Response to U.S. EPR Design Certification Application RAI No. 515, Supplement 4

Response to
Request for Additional Information No. 515, Supplement 4

U. S. EPR Standard Design Certification
AREVA NP Inc.
Docket No. 52-020
SRP Section: 06.02.05 - Combustible Gas Control in Containment
SRP Section: 06.02.01 - Containment Functional Design

Question 06.02.01-103:**OPEN ITEM****Follow-up to RAI 437 Question 06.02.01-97**

Figure 06.02.01-103-1—DEG-CLPS RV-Side Steam Mass Flow Rates**Figure 06.02.01-103-2—DEG-CLPD RV-Side Steam Mass Flow Rates**

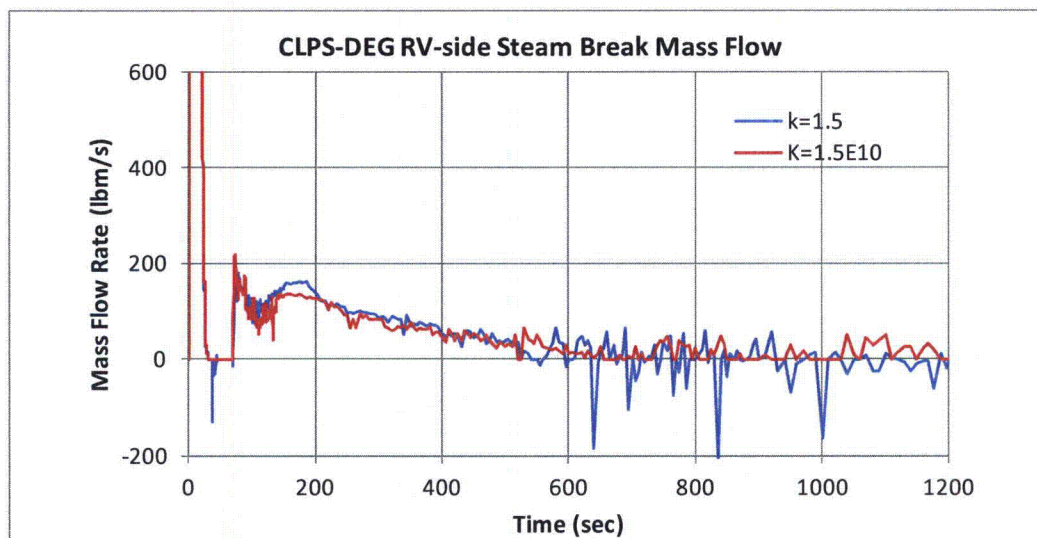
In RAI 437 Question 06.02.01-97, the staff requested AREVA to provide evaluations for the first 1200 seconds for DEG-CLPS break and for the first 3600 seconds for a DEG-CLPD break. The Supplement 6 response only provided the evaluation up to 100 seconds for both breaks while the non-condensable gas mass fraction continuously increases at 100 seconds. The response needs to be expanded up to the first 1200 seconds for DEG-CLPS break and for the first 3600 seconds for a DEG-CLPD break. Provide evaluations of the impact on containment pressure and temperature when the non-condensable gases were ingested into the reactor system during these time periods.

The U.S. EPR containment large break loss of coolant accident (LBLOCA) methodology uses a high reverse flow resistance ($K=1.5E10$) that eliminates potential reverse flows at the break junctions in the RELAP5/MOD2-BW model as demonstrated in Figure 06.02.01-103-1 and Figure 06.02.01-103-1 which shows the mass flow rate is never negative. Sensitivity studies were performed using a nominal reverse flow resistance ($K=1.5$) to quantify the potential impacts of applying a high reverse break flow resistance for postulated cold-leg breaks at the suction and discharge leg of reactor coolant pump.

Sensitivity results from RELAP5/MOD2-BW calculations showed that small reverse steam break flow spikes occurred mostly on the reactor vessel-side (RV-side) at the end of blowdown phase and occasionally during the post-reflood phase. Figure 06.02.01-103-1 and Figure 06.02.01-103-2 compare the RV-side steam break mass flow rates between a nominal reverse flow resistance ($K=1.5$) case and a high reverse flow resistance ($K=1.5E10$) case for the DEG-CLPS and DEG-CLPD scenario, respectively. Figure 06.02.01-103-3 and Figure 06.02.01-103-4 compare the steam generator-side (SG-side) steam break mass flow rates between the two cases.
